London Luton Airport Expansion

8.45 Holiday Inn Acoustic Barrier - Change Notification

Application Document Ref: TR020001/APP/8.45

Deadline:	Deadline 3
Planning Inspectorate Scheme Reference:	TR020001
Document Reference:	TR020001/APP/8.45
Author:	Luton Rising

Figure 2.1 Extract of the **Land Plans [AS-011]**

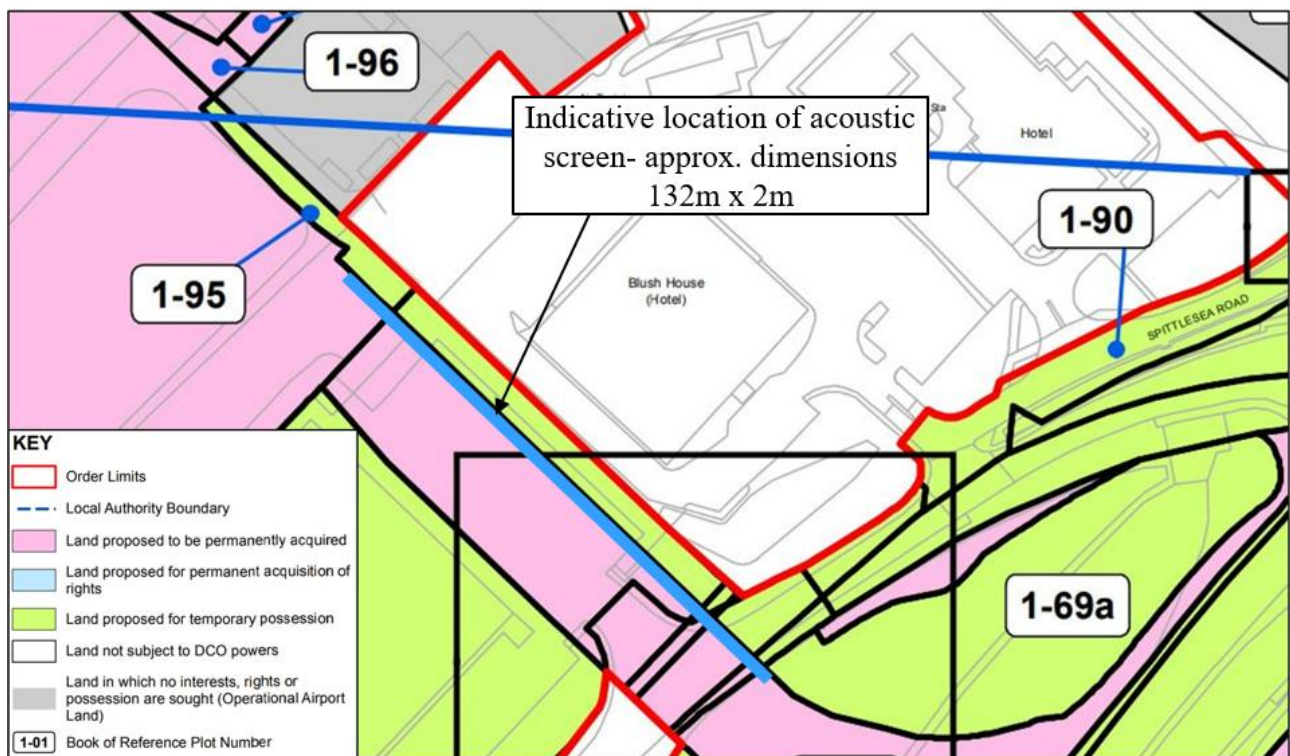
2.2.4 The proposed acoustic barrier, affixed to the new Airport Access Road bridge, would be erected on land which the Draft DCO seeks the power to permanently acquire, within the area depicted for Work No. 6a(02), as shown in the **Work Plans (Part 6 of 6) [AS-017]**. There is, therefore, no change required to the Order Limits, or to the land rights sought within the Order Limits. Figure 2.1 below is an extract of sheet 1 of the **Land Plans [AS-011]** and shows the land over which it is proposed the Applicant will exercise powers of compulsory acquisition or any right to use the land. Holiday Inn is marked as 'Blush House (Hotel)' and the land upon which the acoustic barrier is proposed is marked pink as 'land proposed to be permanently acquired'.

Drawing Title
**AIRPORT ACCESS ROAD
 - INDICATIVE ACOUSTIC
 BARRIER LOCATION**

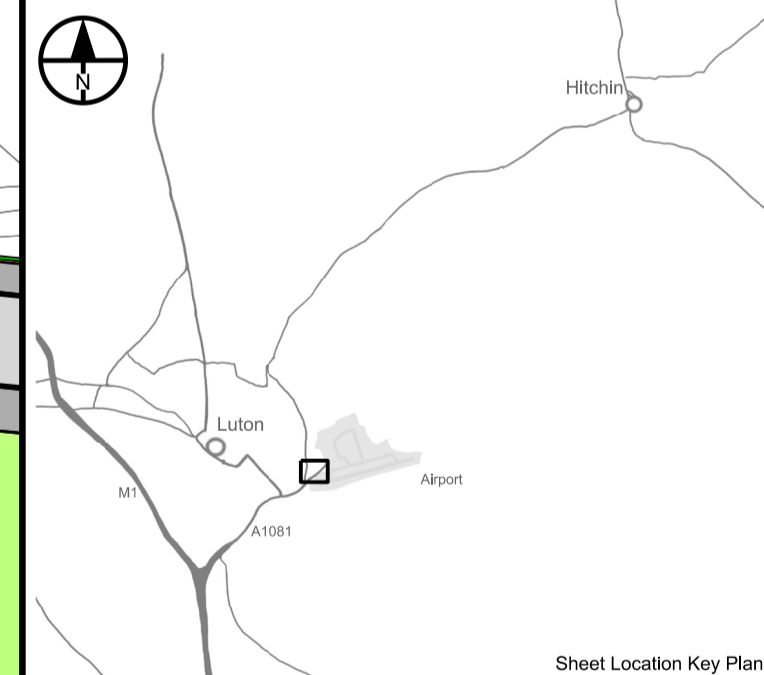
- 2.2.2 Drawing LLADCO-3C-ARP-SFA-HWM-DR-HY-1510 (contained within Appendix A of this document) is based upon the indicative drawing shown in the New Century Park Access Road application (17/02300/EIA), drawing no. D-Q30131-H-0101.

- 2.2.3 The new Airport Access Road will be elevated on a bridge above Airport Way and pass between the Holiday Inn and Preservation House. The proposed acoustic barrier would be positioned on the parapet of the bridge’s northern

side, adjacent to the hotel. In accordance with the details in the extant New Century Park Access Road permission (17/02300/EIA), the barrier would be 132m in length by 2m high. The exact form and structure of the noise barrier would be considered at detailed design stage in accordance with the requirements of the Design Manual for Roads and Bridges (Ref 2.1) using a proprietary system.
